**OIL SANDS CO-PRODUCTION EXPERIMENTAL PROJECT
SUPPLEMENTAL INFORMATION REGARDING
AEUB APPLICATION NO. 950993
AEP APPLICATION NO. 001-17233**

OCTOBER 1995

Subject: Application No. 001-17233
THE OIL SANDS CO-PRODUCTION EXPERIMENTAL PROJECT
LEASE 7276120T05

This submission is in response to a September 19, 1995 letter from the Alberta Energy and Utilities Board (AEUB) and a September 20, 1995 letter from Alberta Environmental Protection (AEP) to the SOLV-EX Corporation.

Figure QB1.1

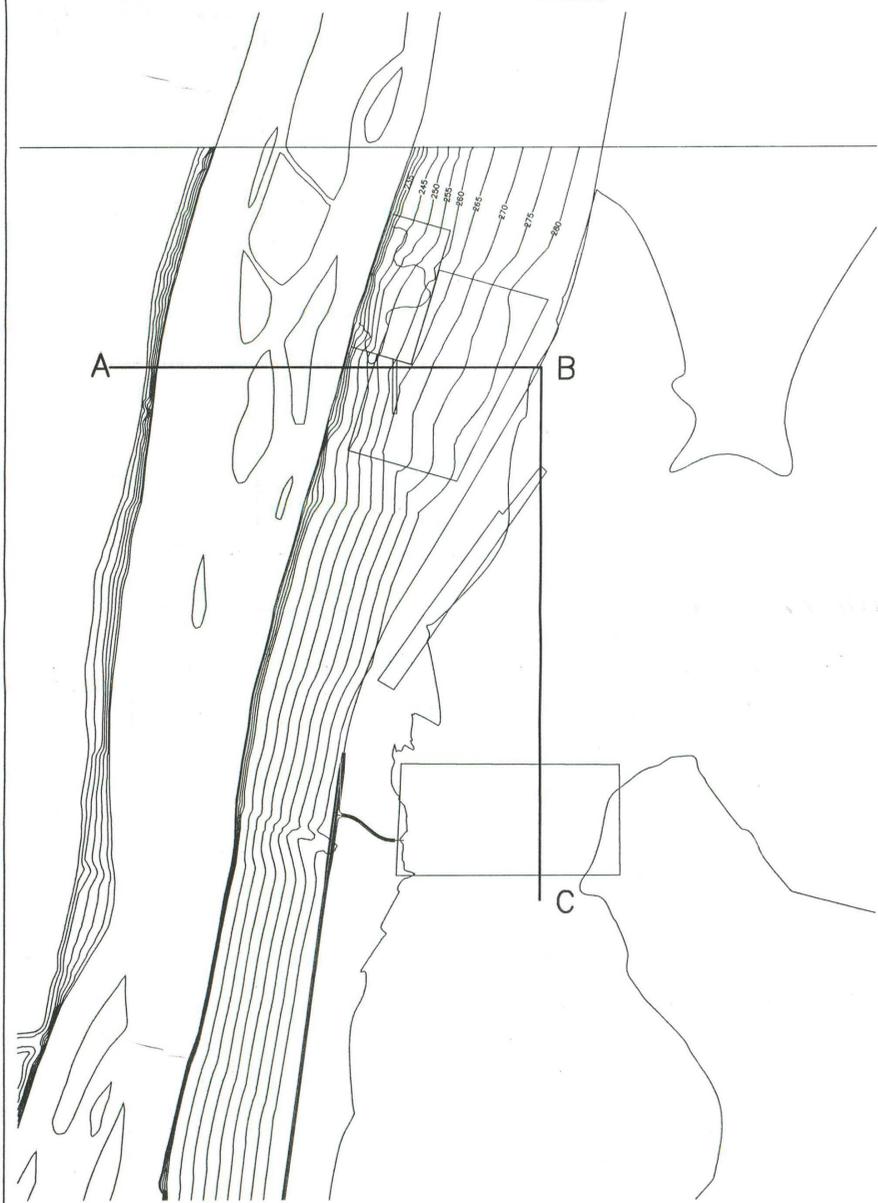
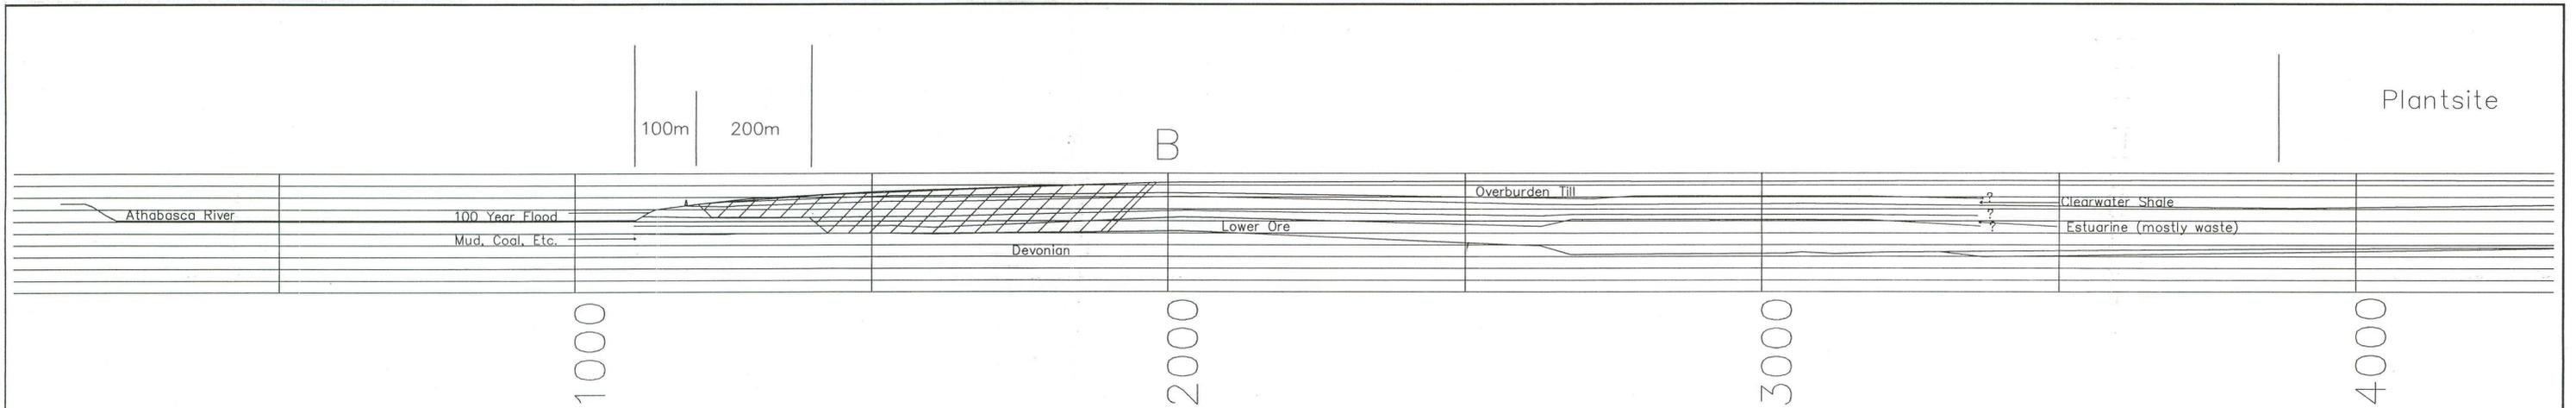
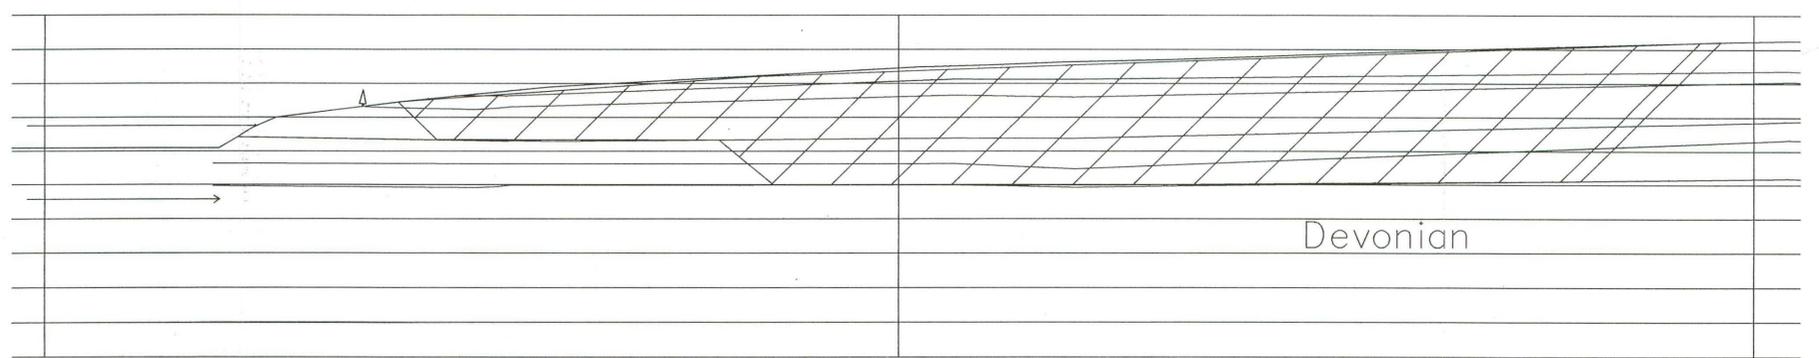
QH3. *Show the 1:100 year floodlevel and the proposed mine site in relation to this floodplain on a map.*

QI2. *Provide cross-sections from the Athabasca River through the pit across the winter road and plant site and show the final contours of the mined-out area in relation to the Athabasca River. Include the final elevation of the groundwater table at the end of mining. Show and discuss the groundwater gradient and whether there is potential for water to move between the river and the mine pit. Discuss the potential for contamination of the Athabasca River from the mine pit.*

- **Floodplain:** The 1:100 year flood level has been estimated to be 235 m and is located at least 85 m west of the proposed mine boundary (see Figure QB1.1, included in Attachment B1 of Appendix A). The setback will accommodate the natural evolution of the path of the river. The 1:100 year and maximum estimated ice breakup levels were determined from:
 - River surveys by Alberta Research Council (Kellerhals, R., Neill, C.R. and Bray, D.I., "Hydraulic and Geomorphic Characteristics of Rivers in Alberta"),
 - Design water levels computed for the Highway 63 bridge upstream and using map-determined river slopes to extrapolate to the SOLV-EX site,
 - Observations by Alberta Research Council and Alberta Environmental Protection staff during breakup (personal communication), and
 - Streamflow data for the Athabasca River as monitored by Water Survey of Canada at Fort McMurray.

Answer: As shown on Figure QB1.1 (of Attachment B1, Appendix A).

Answer: A conceptual cross-section is shown in Figure 2.5 of the EIA. Figure QB1.1 augments this cross-section, although it shows only the current groundwater gradient. Fourteen monitoring wells up to a depth of 80 m were installed on the site. Water levels and groundwater samples were collected during late August 1995. Also, tests for hydraulic conductivity were conducted on selected monitoring wells.
